RE: TRINITY STAGE 2 BUILD-TO-RENT HOUSING DEVELOPMENT
RESPONSE TO MATTERS RAISED BY AUTHORITIES

As requested, we are writing with regards to traffic and parking matters raised by Ryde City Council for the State Significant Development Application (SSD-55844212), for the Trinity Stage 2 Build-to-Rent housing development at 39 Delhi Road, North Ryde.

12.5m LARGE RIGID VEHICLE
SWEPT PATHS

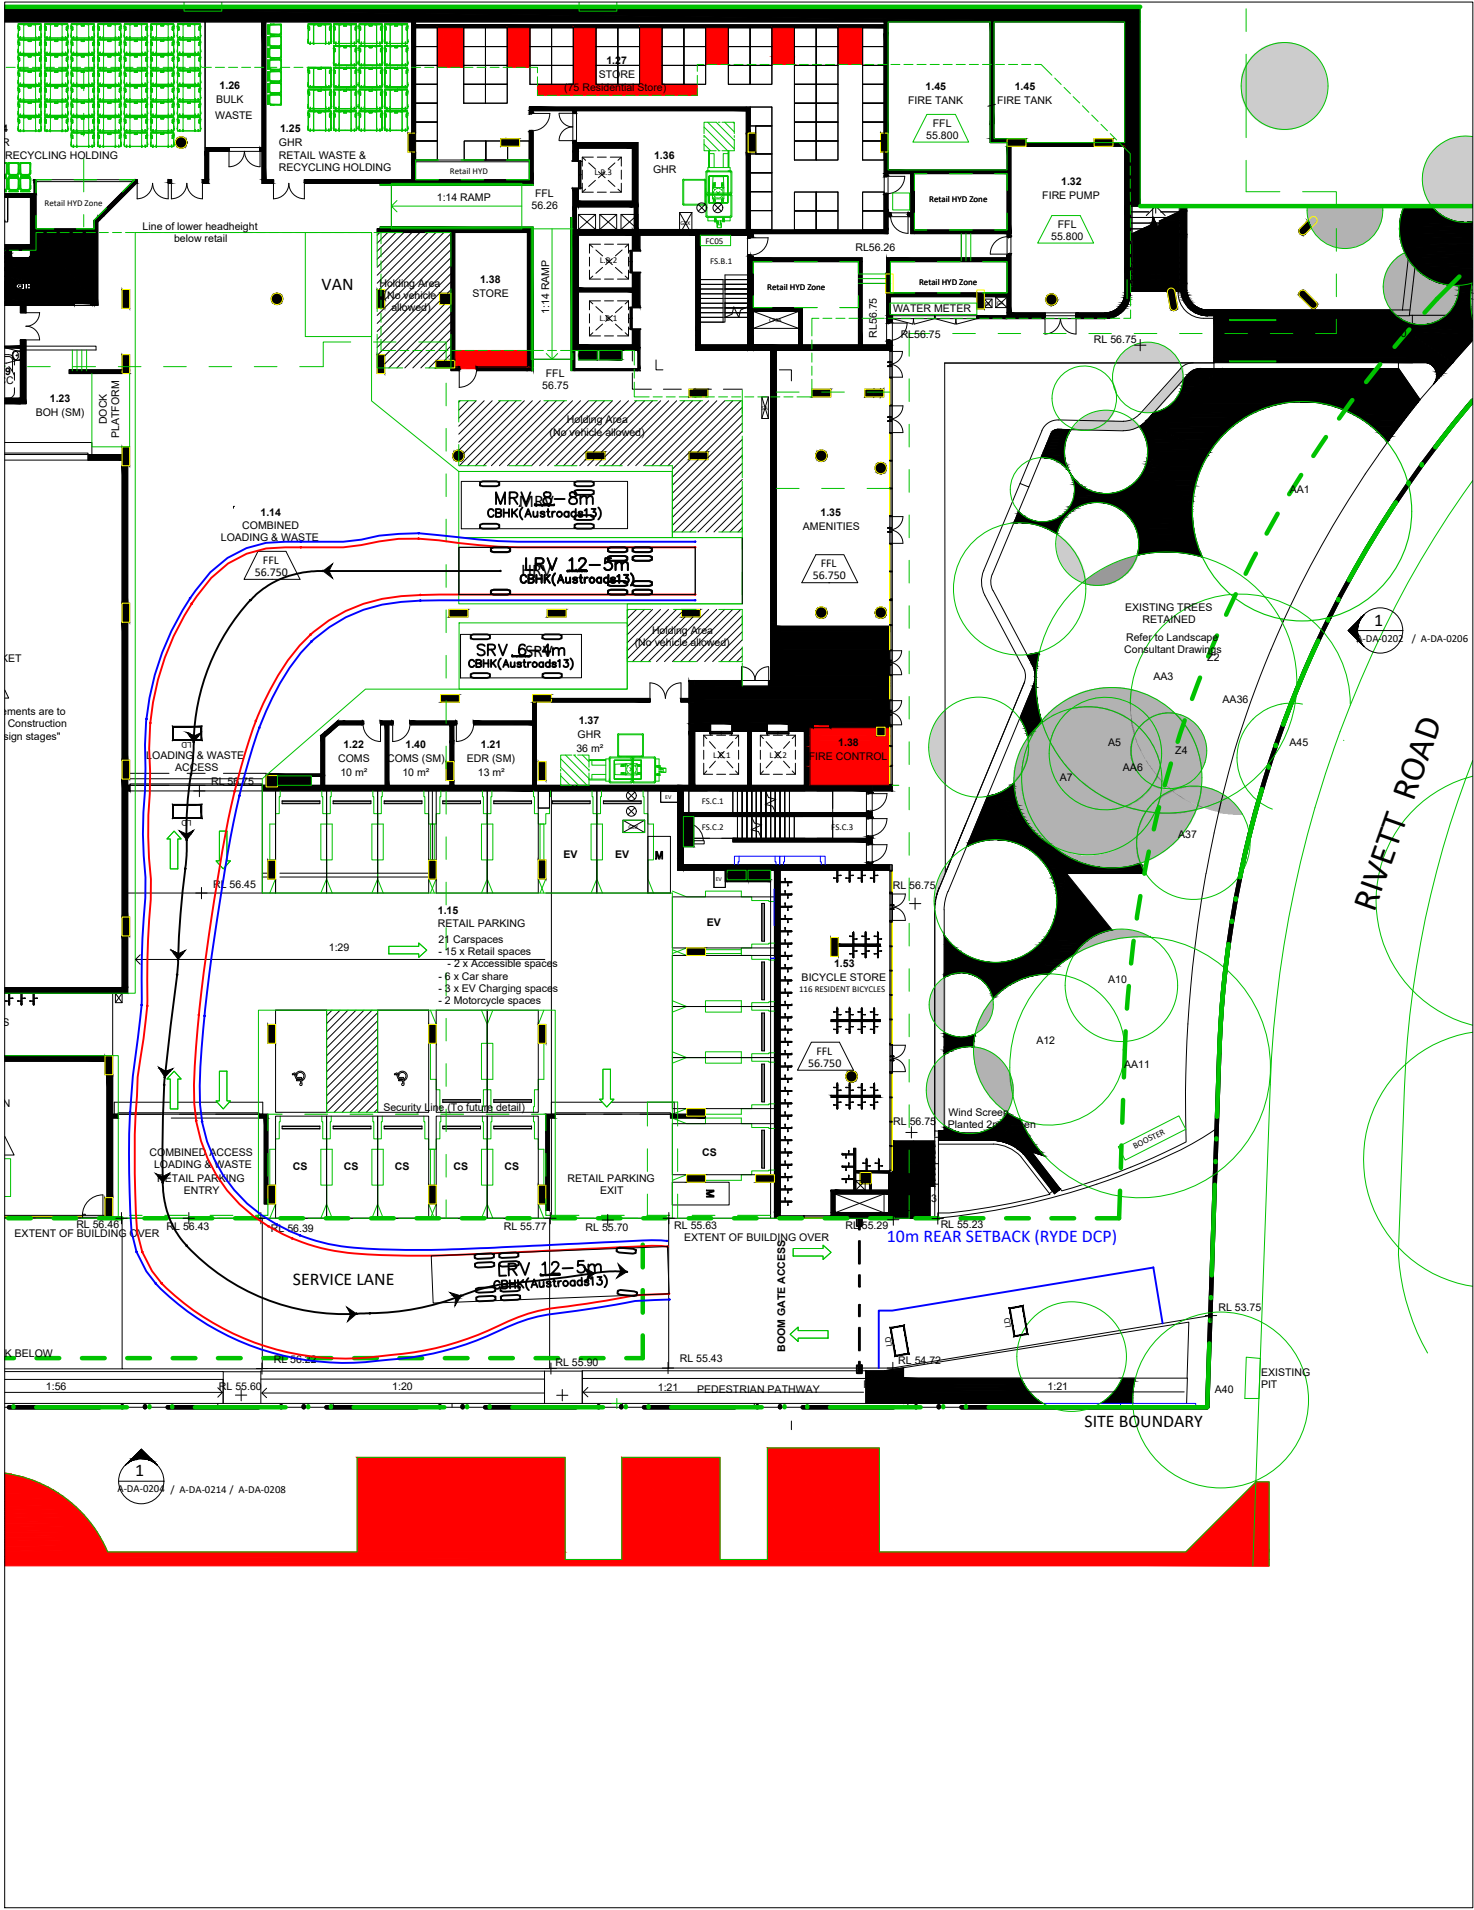
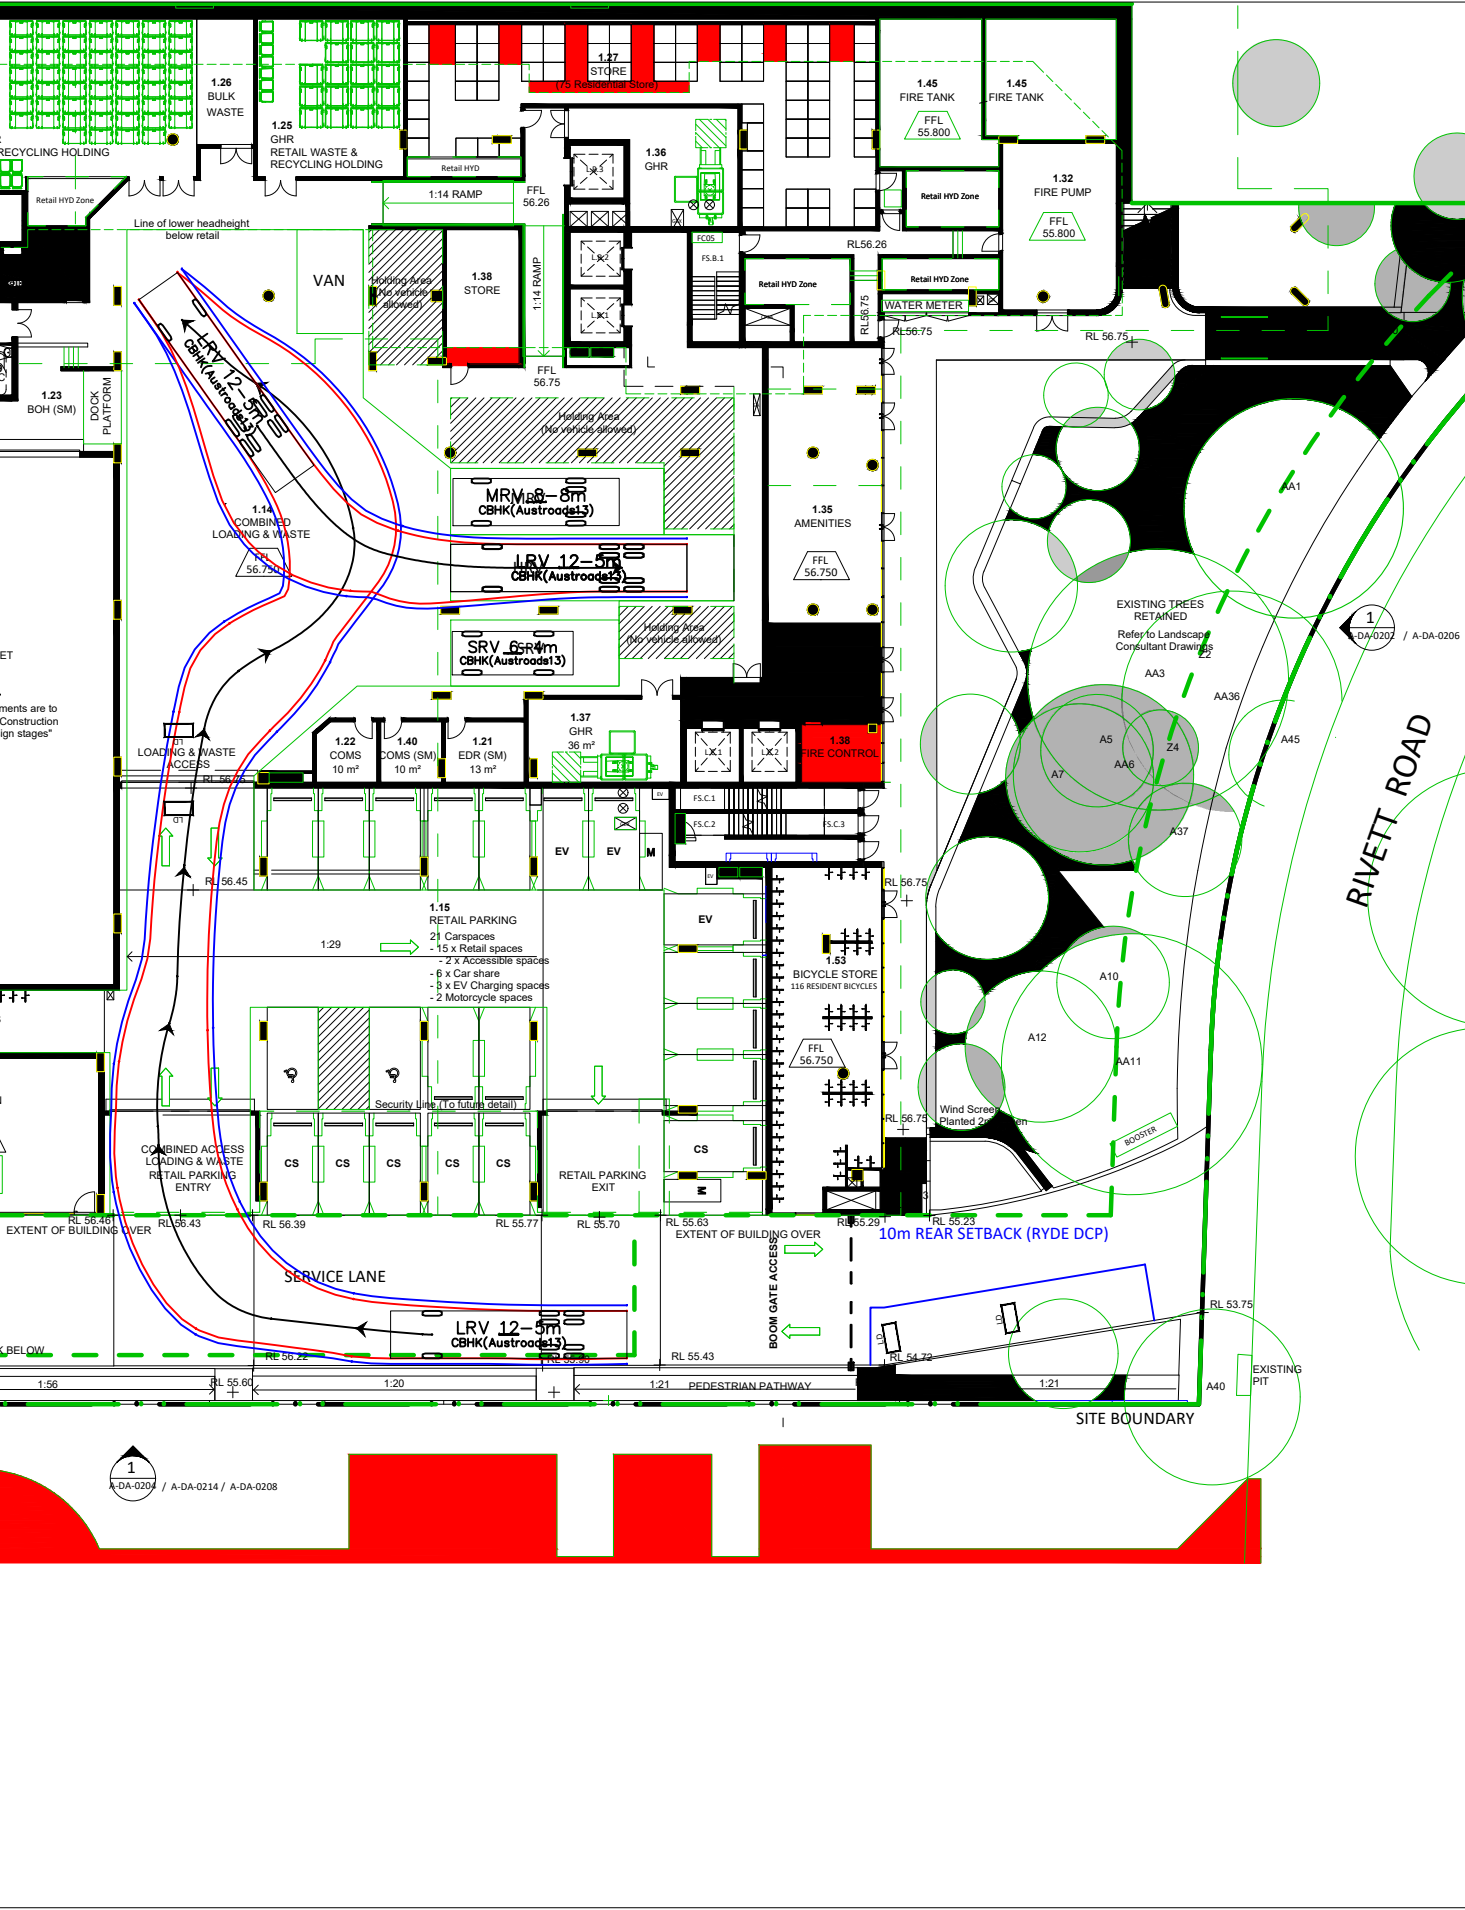
- *The swept paths (Appendix N - TALA, pgs 69-74) show multiple intrusions in the clearance to vehicle body envelope (which includes the mirrors).*
- *The swept paths show the HRV having to mount the pedestrian walkway at the south of the property to turn into the loading dock.*

Figure 5 indicates that the swept path of the HRV entering or exiting the site will not encroach onto the pedestrian walkway located on the southern side of the internal service road.
